GROUP ACC	MODEL 2014MY Forte (YD)
	NUMBER 008	DATE October 2013
TECHNICAL SERVICE BULLETIN		
SUBJECT: SERVICE ACTION: GAP BETWEEN FORTE SPOILER AND TRUNK LID (SA154)

**SERVICE ACTION: GAP BETWEEN FORTE SPOILER
AND TRUNK LID (SA154)**

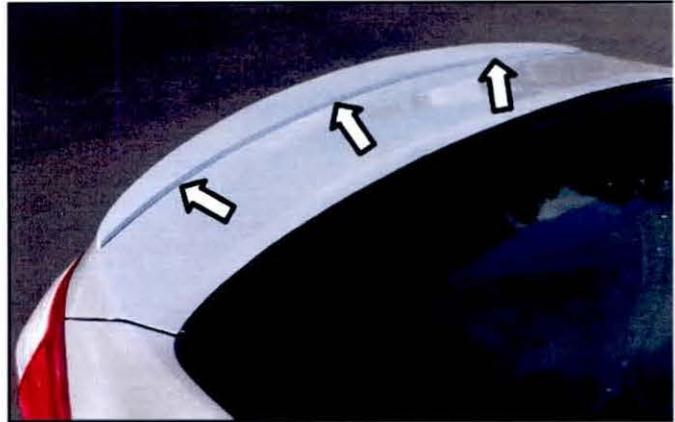
1. Inspect leading edge of the spoiler for a possible gap forming between the spoiler and the trunk lid.

2. If any gaps are present, use a 1mm plastic feeler gauge to measure the separation.
 - If the gap is equal to or greater than 1.0 mm, remove and replace with a new spoiler by carefully following the instructions included with the new accessory part.
 - If the gap is less than 1.0 mm, proceed to Step 3.

Do not use metal feeler gauges or paint damage may occur.

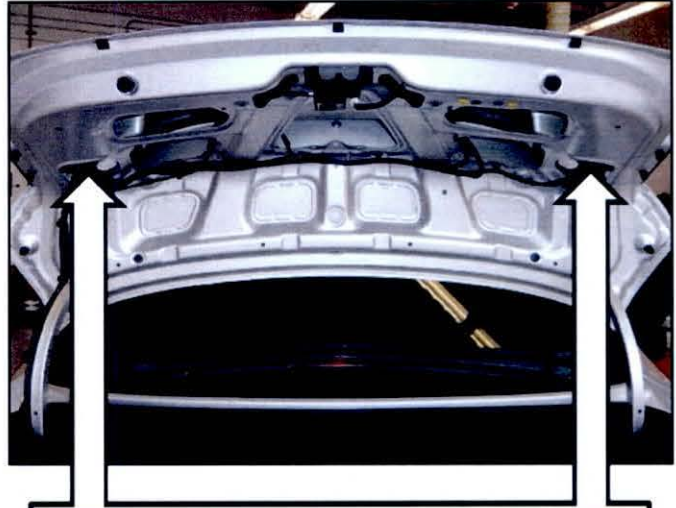
3. Open the trunk and remove the insulation trim panel.

4. Inspect the retaining clips to make sure the hooks are properly engaged on the underside of the trunk.

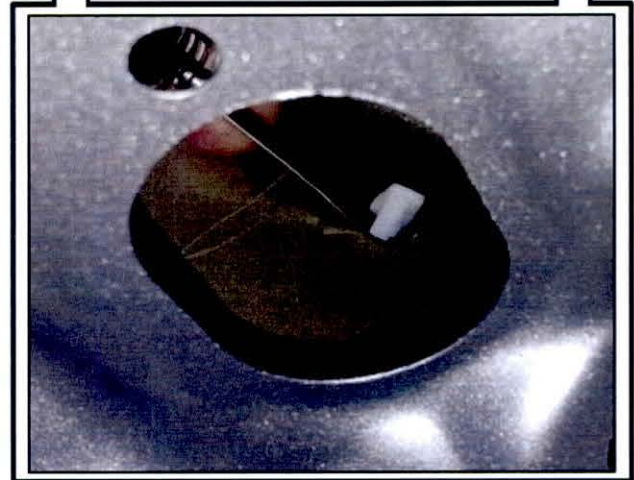
5. If the hooks are not properly engaged, use a flat-head screwdriver to gently spread the clip open, as shown.

If necessary, have an assistant apply downward pressure to the spoiler while spreading the clip open.

Be careful not to damage the clips.
